COUNTY OF LOUDOUN
DEPARTMENT OF BUILDING AND DEVELOPMENT
ZONING ADMINISTRATION REFERRAL

DATE: January 30, 2008
TO: Mike Elabarger, Project Manager
Department of Planning
THROUGH: Marilee L. Seigfried, Deputy Zoning Administrator
FROM: Michelle M. Lohr, Planner
TAX MAP/PARCEL: /45//10/////2/ **MCPI:** 455-17-3739
CASE NUMBER & NAME: SPEX 2007-0048 Springdale Montessori School

COUNTY OF LOUDOUN
DEPARTMENT OF BUILDING AND DEVELOPMENT
ZONING ADMINISTRATION 2nd REFERRAL

FIGURE C-1-1.7

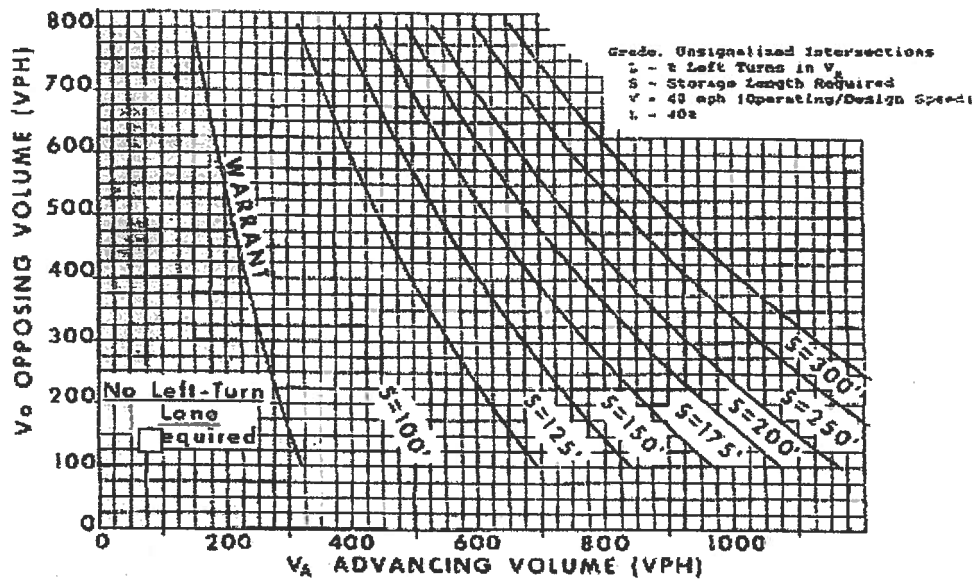
2008/2009 Total Future	Lincoln Road(Road 722)/Site Entrance
	Southbound Left-Turn Lane Evaluation
	AM
V_A = Advancing Volume	87
V_O = Opposing Volume	136
Left-Turns	34
Symbol	<input type="checkbox"/>

WARRANT FOR LEFT-TURN LANES ON TWO-LANE HIGHWAYS

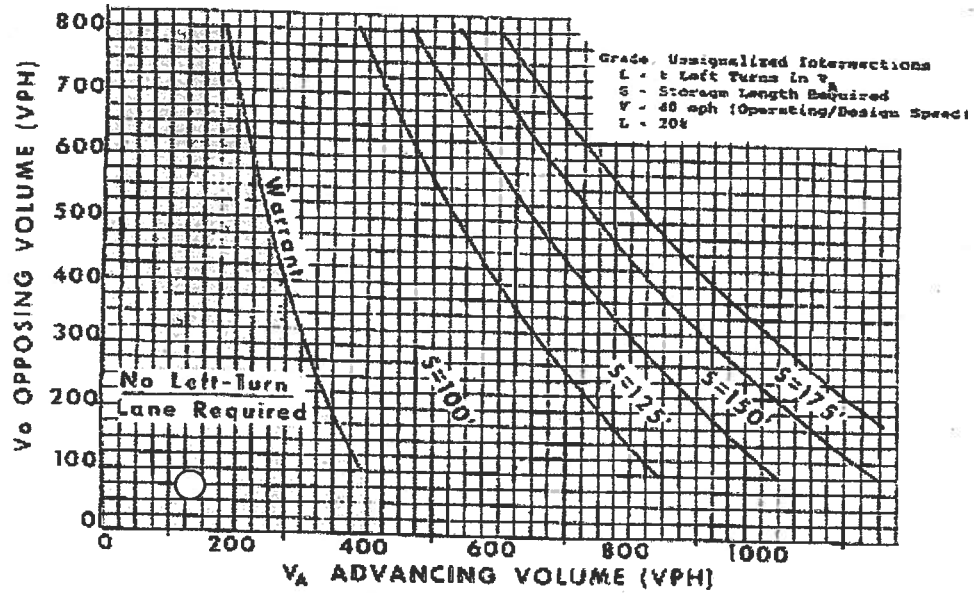
2008/2009 Total Future	Lincoln Road(Road 722)/Site Entrance
	Southbound Left-Turn Lane Evaluation
	PM
V_A = Advancing Volume	117
V_O = Opposing Volume	70
Left-Turns	24
Symbol	○
